**Manual Updates for  
A Couple of Mazda Valve Bodies**

**TRANSMISSION DIGEST CORRECTION  
January 2004 Issue  
Page 12**

Figure 4

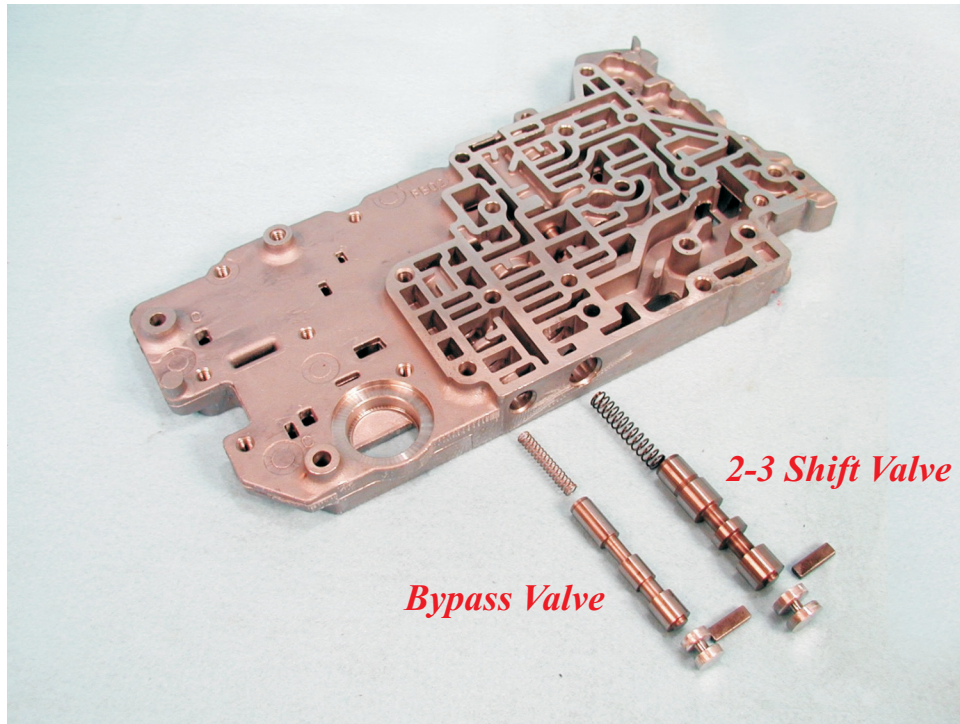
Another manual update that would be good to make is with the F4EAT transaxle. The 2-3 Shift Valve and the Bypass Valve are side by side near the inlet port of the valve body as seen in Figure 4. These valves have been oppositely labeled. This error can lead to a no 2-3 up shift problem after overhaul. The reason for this is that many technicians peg the bypass valve to allow for a firmer 2-3 shift. This works with the G4A-EL, the GF4A-EL and the F4EAT transaxles alike. If a technician is unaware of the mislabeling of the valves in F4EAT valve body information, the 2-3 shift valve is unknowingly pegged preventing the 2-3 shift to take place. One way to remember the correct valve is that the Bypass Valve is closest to the inlet and that the 2-3 Shift Valve is the larger of the two.
